PBOT Evaluation of Build v No Build conditions for bicycling with the I-5 Rose Quarter Improvement Project

Using the Oregon Department of Transportation's (ODOT) Environmental Assessment (EA) of the I-5 Rose Quarter Improvement Project as its basis, this document offers the following:

Lloyd District to/from Steel Bridge

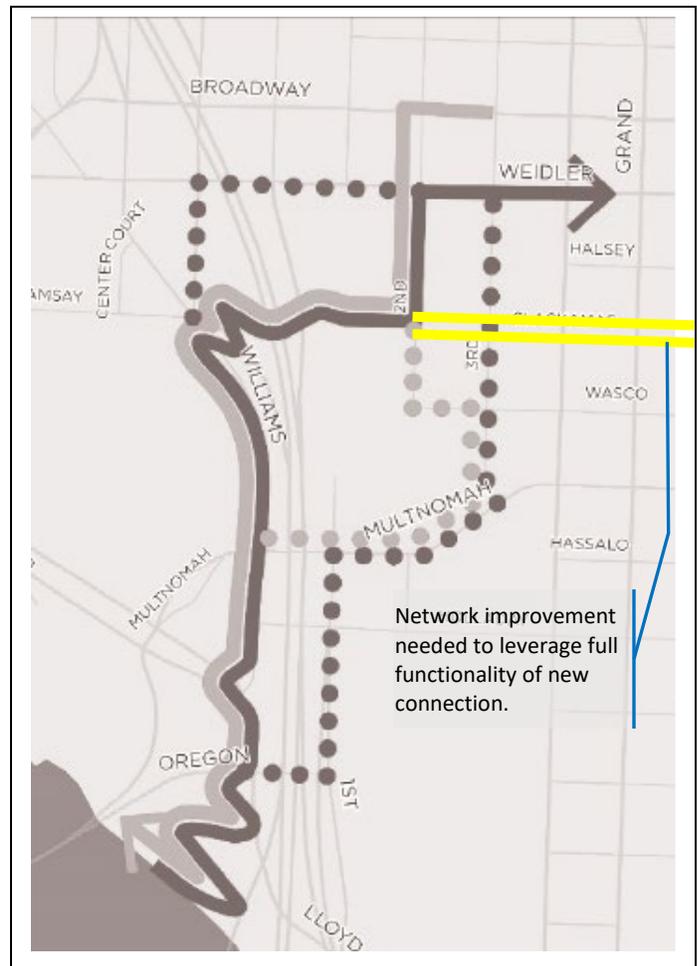
The Build scenario trip is longer but goes through one fewer signalized intersection than the trip for the No Build scenario.

Travel Route <i>(Broadway/7th to/from Interstate/Williams)</i>	Delay		Comments	Considerations for design
	Distance	# signals		
Inbound				
via Clackamas structure	+960'	-1	The No Build route assumes a path south to Multnomah, which is quicker than Broadway to the 2 nd Avenue neighborhood greenway. Because the Build route substitutes a shared roadway on Clackamas for a protected bicycle lane on Multnomah, that segment is worse than the No Build.	Clackamas is a shared roadway. Improvements would be necessary to fully leverage benefit of new bridge.
via 2 nd Avenue	+610'	-1	Shorter than using the Clackamas structure, the use of the shared roadway on Clackamas is worse than using the protected bicycle lane on Multnomah.	
Outbound				
via Clackamas structure	+960'	-1	Similar to inbound direction.	Same as above.
via 2 nd Avenue	+610'	-1	Similar to inbound direction.

Lloyd District to/from Steel Bridge (starting/ending at 7th & Clackamas)

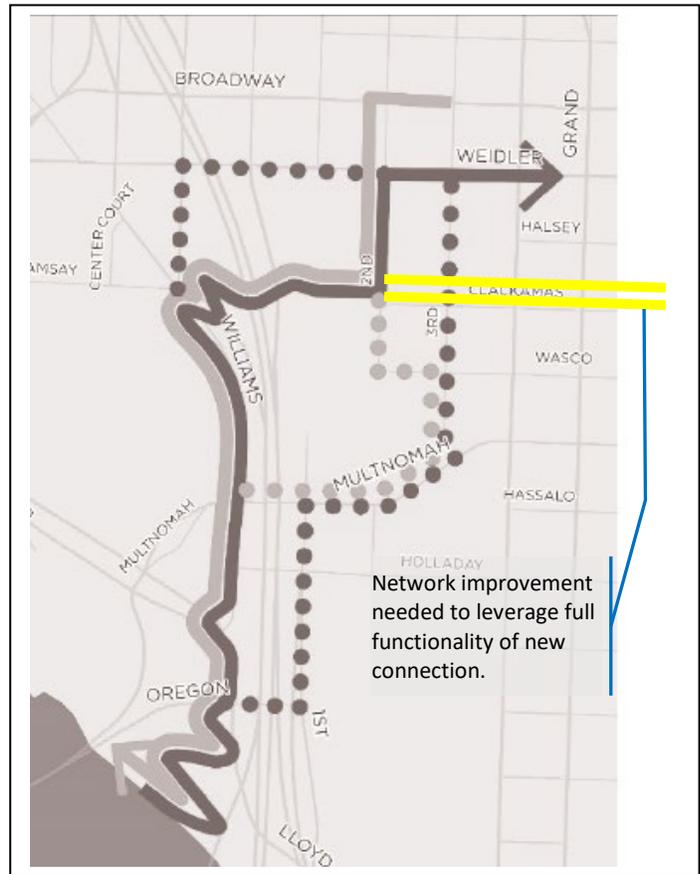
Because the No Build uses 7th bicycle lanes along 7th Avenue and a protected bicycle lane on Multnomah, the facilities along Clackamas (shared roadway) are worse.

Travel Route (Clackamas/7th to/from Interstate/Williams)	Delay		Comments	Considerations for design
	Distance	# signals		
Inbound				
via Clackamas structure	+960'	-1	Clackamas as a shared roadway offers a lesser quality facility than does 7 th and Multnomah.	Clackamas is a shared roadway. Improvements would be necessary to fully leverage benefit of new bridge.
Outbound				
via Clackamas structure	+960'	-1	Same as for inbound via Clackamas.	Same as above.
